MOBILE HOME BASEMENT

17185 SAGE CREST RD.  
PEYTON, CO. 80831

FOUNDATION  
PLAN AND  
SECTION

S1

NORTH  
FOUNDATION PLAN  
1/4" = 1'-0"

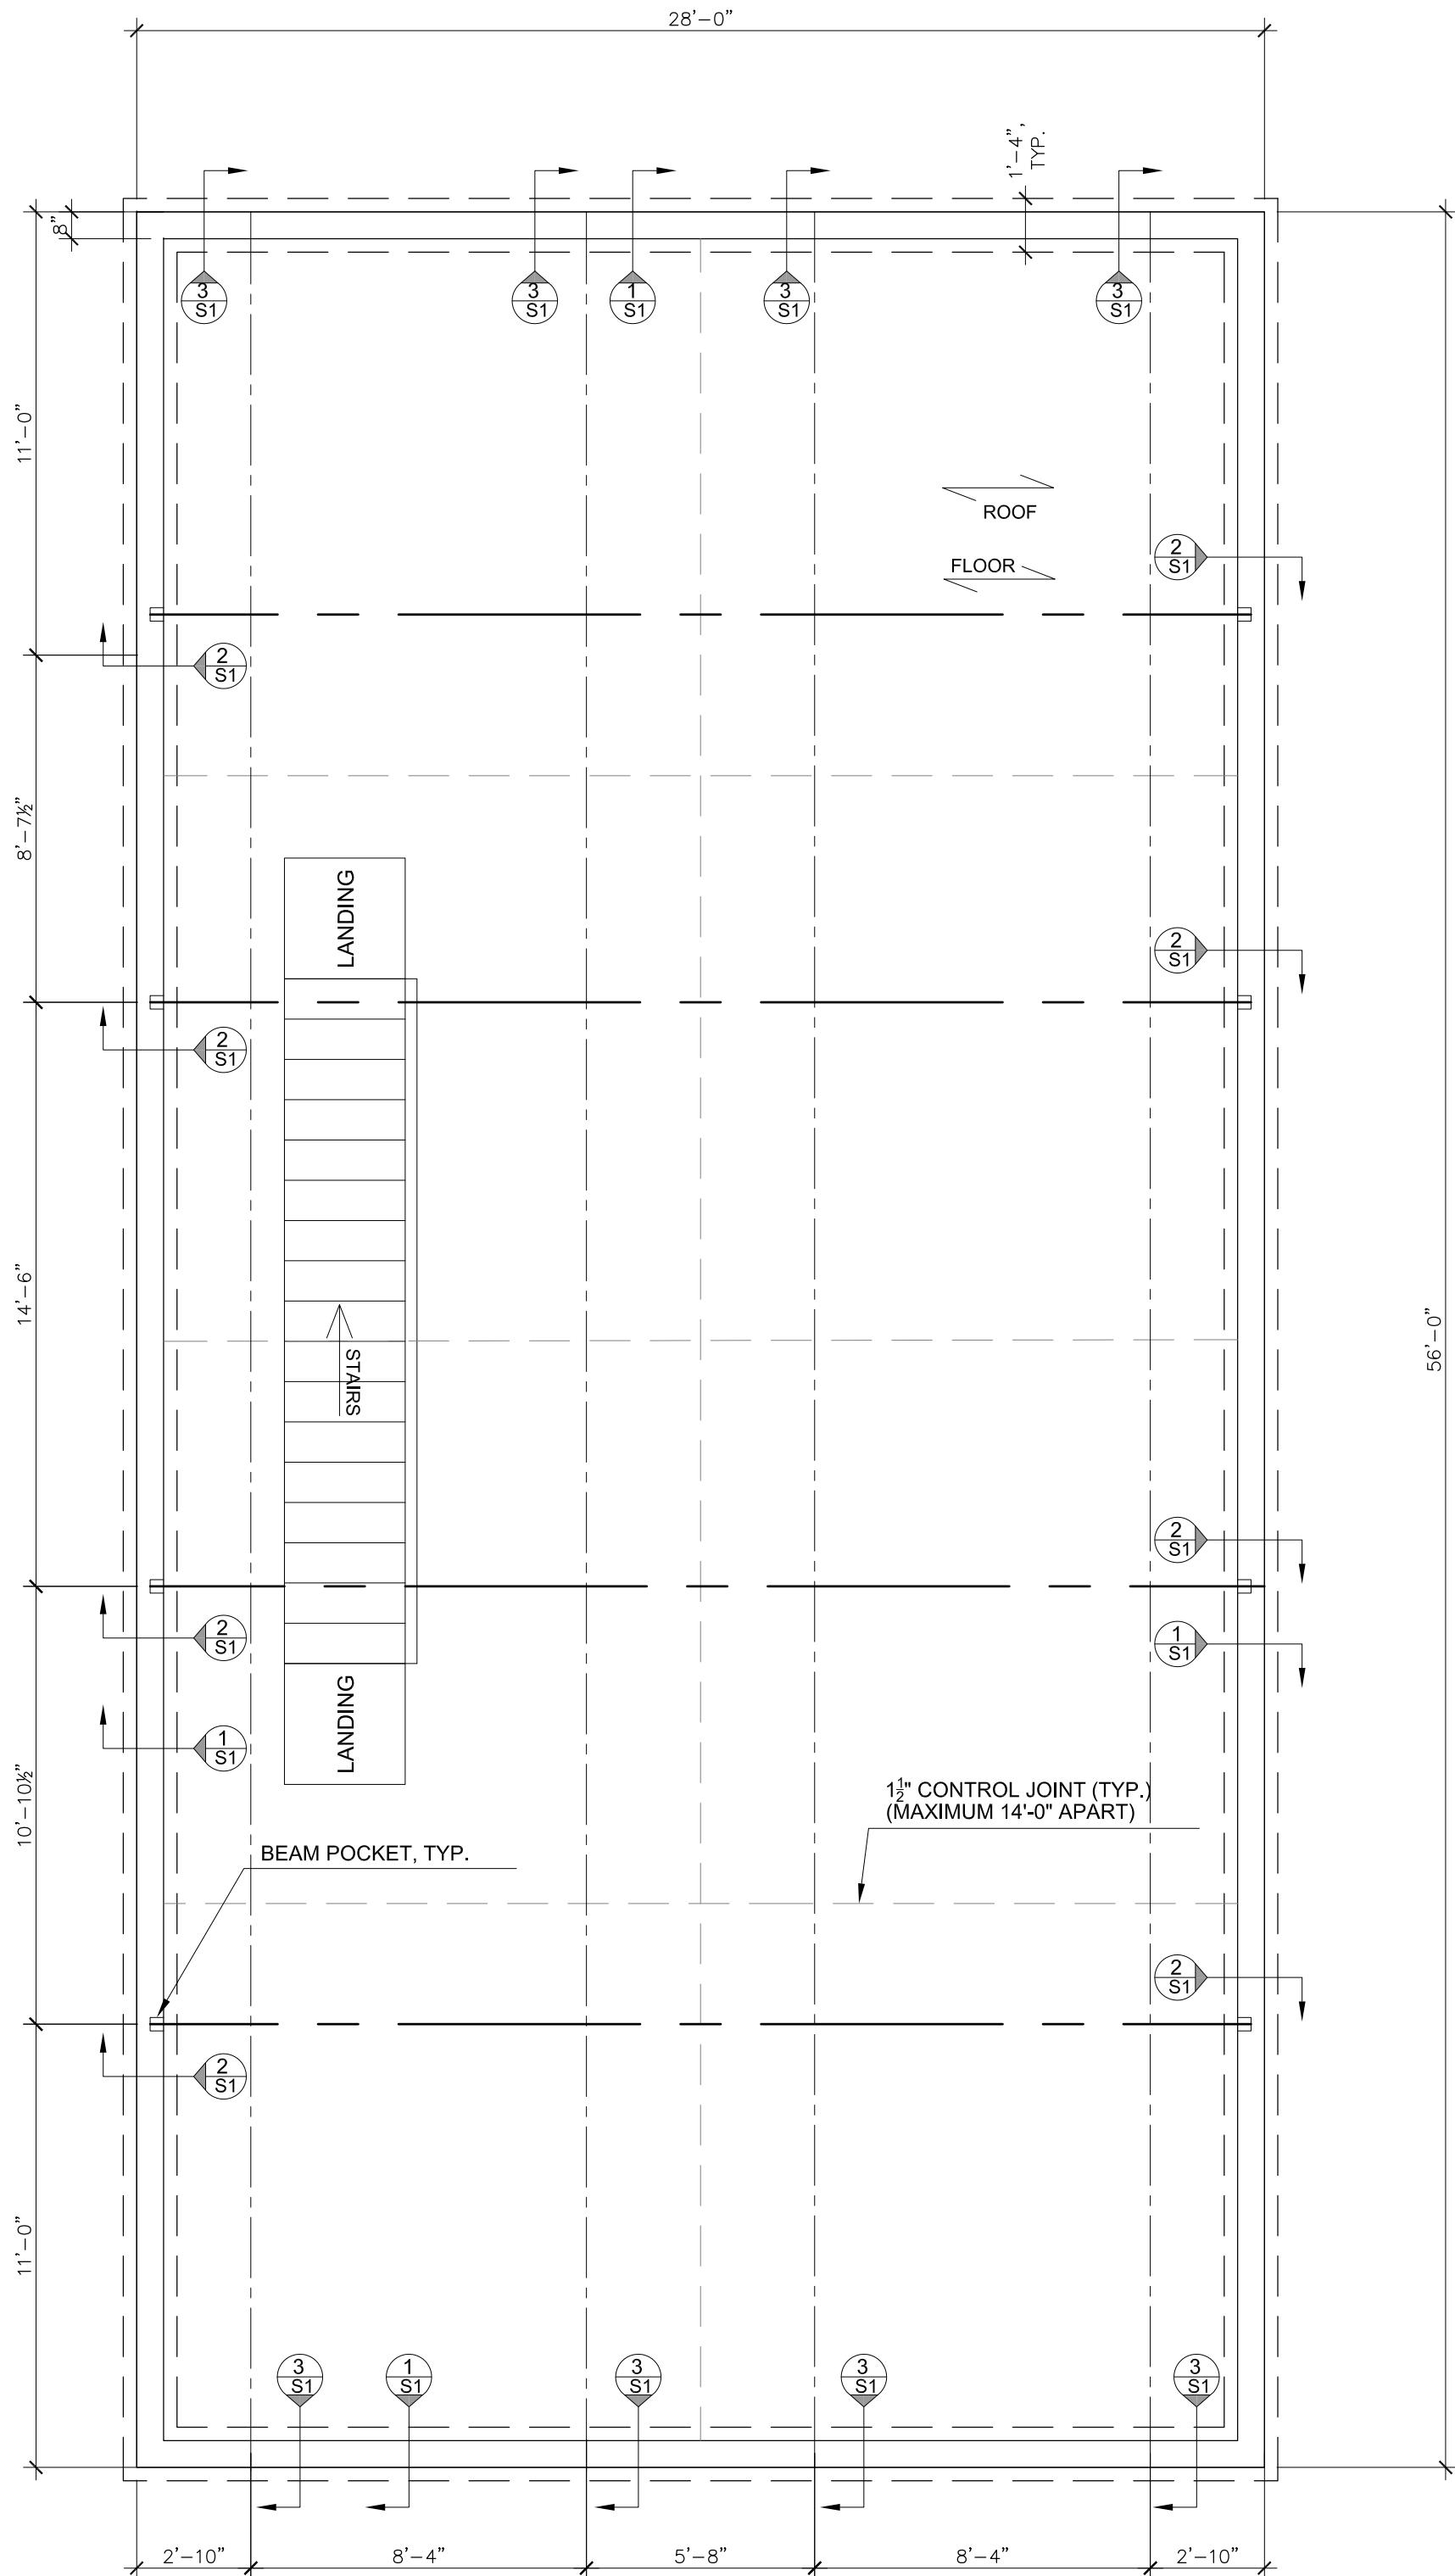
Provide stair/ landing framing drawings.

130 mph Vult is minimum wind speed design.
